ATTACHMENT 2 TO AEP:NRC:0896H

REVISED PAGES FOR THE

DONALD C. COOK NUCLEAR PLANT UNITS 1 AND 2

TECHNICAL SPECIFICATIONS

Figure 1

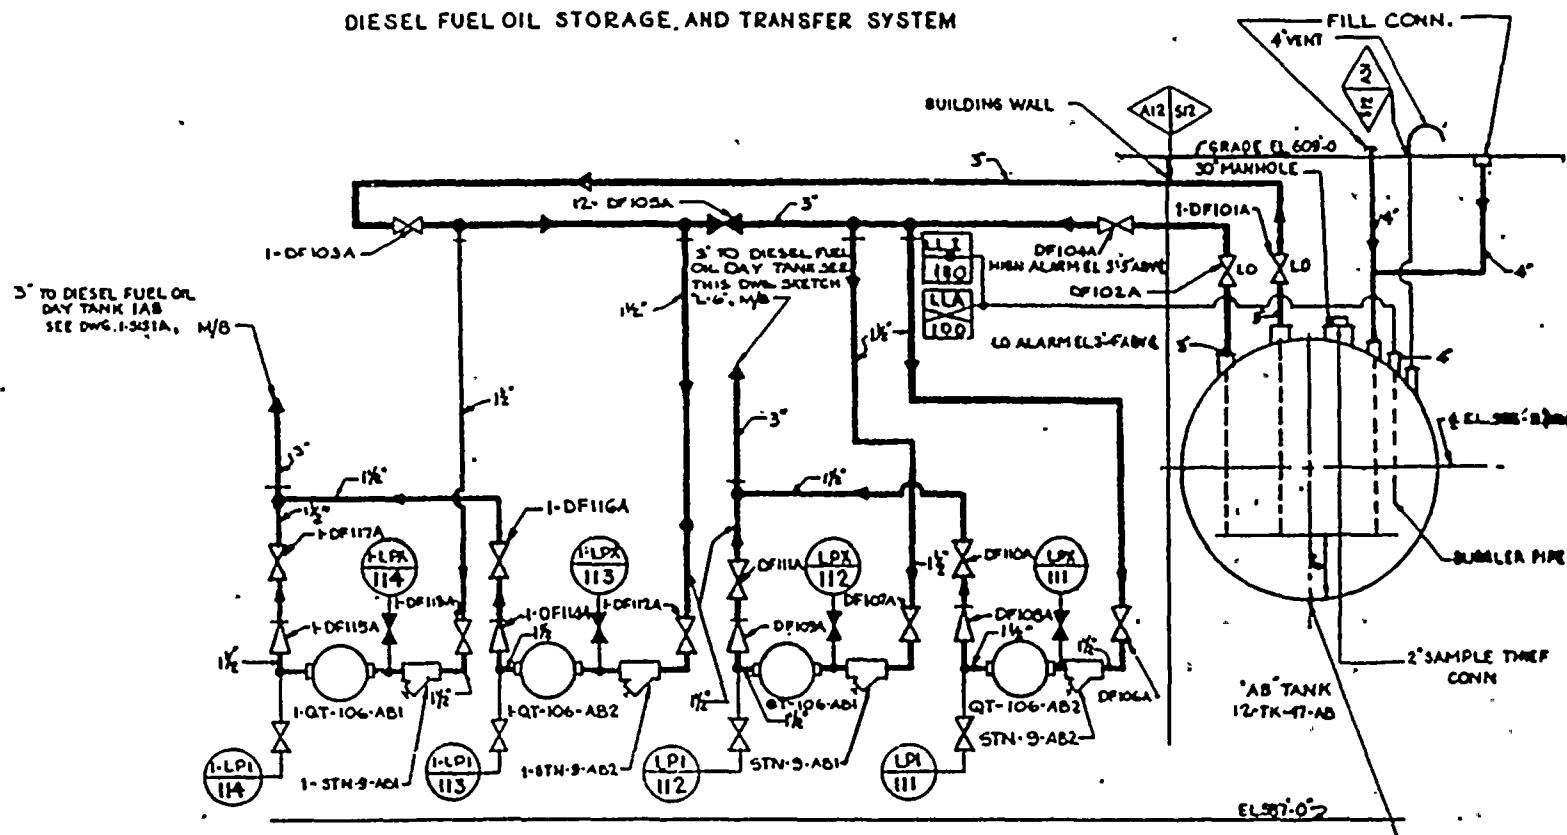
As shown on Figures 1 and 2, the "AB" tank supplies fuel to the Unit 1 "AB" diesel generator and the Unit 2 "AB" diesel generator, while the "CD" tank supplies fuel to the Unit 1 "CD" diesel generator and the Unit 2 "CD" diesel generator. Figure 3 shows the location of the tanks relative to each other. There is no cross-tie between the tanks; therefore, to empty either tank to clean it would require making a diesel generator in each unit inoperable. Since cleaning the tanks cannot be accomplished within the 72-hour Action Statement of T/S 3.8.1.1, emptying the tanks to clean them would require both units to be shut down.
